## 114.8 Medium Dependent Interface (MDI)

### 114.8.1 MDI mechanical interface for 1000BASE-RHA

**Figure 114–2—Duplex POF cable splitting and connection to the 1000BASE-RHA MDI receptacle**

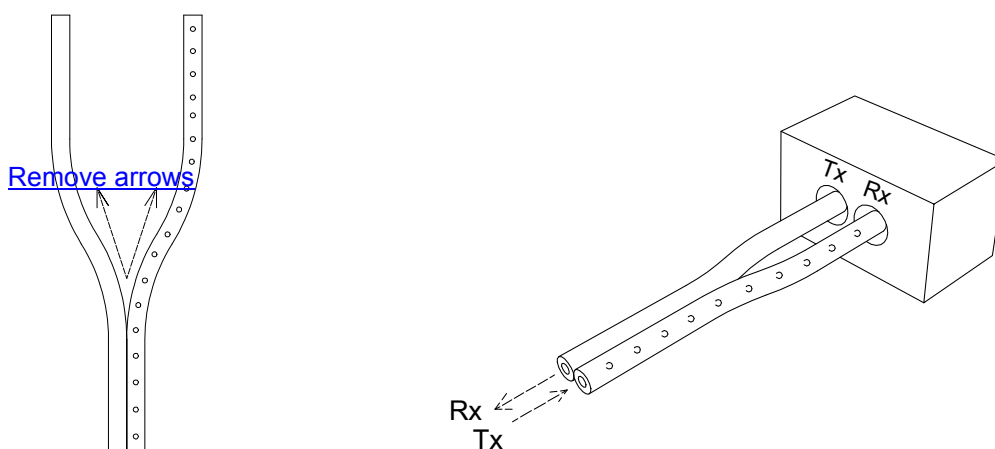
The 1000BASE-RHA MDI receptacle connector vendor shall properly clearly indicate the minimum split length needed for a suitable connection. Left side of Figure 114–2 illustrates the duplex POF cable splitting and the right side the fiber cable connection to 1000BASE-RHA MDI receptacle.

One of the jackets of the duplex POF cable shall have marking. A possible marking is illustrated in Figure 114–2. Such marking can facilitate installation when the optical transmitters of the link are off. There may be specific application marking requirements ~~are application specific, and shall follow the requirements in IEC 60794-2-41.~~
